Response to: MACKINAW 12-28/KING 12-28 API #: 043-06201, 06211; FIR Doc#:695106751

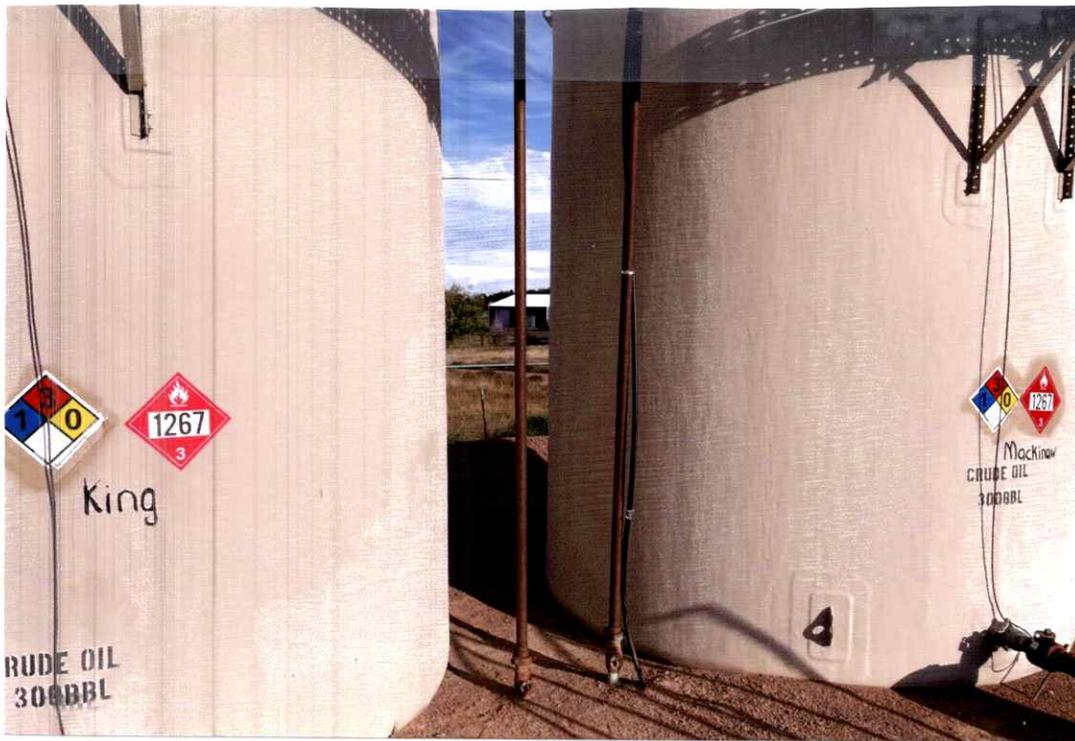
Gas being vented or flared during non-upset condition without prior approval from COGCC. **THIS INSPECTION DUE TO COMPLAINT DOC #403164238, IN REFERENCE TO APPEARANCE OF VENTING.** CA: Immediately cease venting/flaring. PER RULE 903. Contacted Liz Harkins appearance of continuous venting out of the 2" on top of both tanks. It appears that the backside is plumbed to tank battery with a buried 1" line. At time of inspection the 1" line is closed.

-Upon phone notification by COGCC Field Inspector Tom Beardslee, Operator immediately dispatched crew to investigate suspect venting out of tank (casinghead valve plumbed to 1" upset condition vent line to tank was supposed to be in closed position). Crew advised that ball valve was leaking and took immediate action to bull plug valve and also capped 1" vent line at inlet and outlet; Also bull plugged vent stack on top of tank.

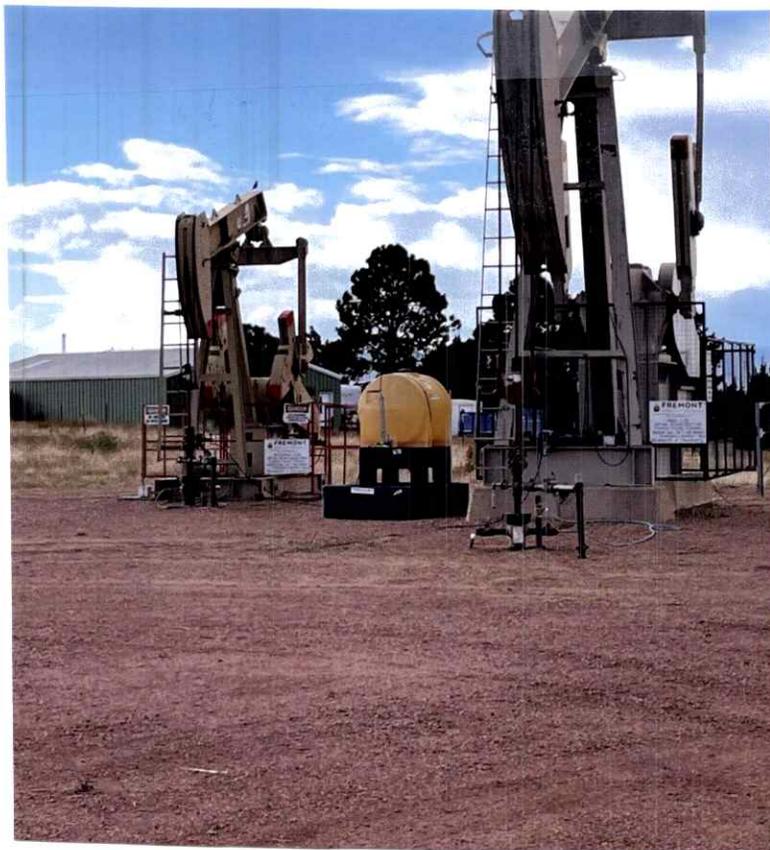
Tank labels (NFPA, Capacity, Contents). CA: Install sign to comply with Rule 605.h.
-Crew replaced worn placards and identified well names.

Unused equipment stored on location. CA: Remove unused equipment per Rule 606.
-Removed 28 damaged rods on ground that had been retrieved during a rod-part repair.
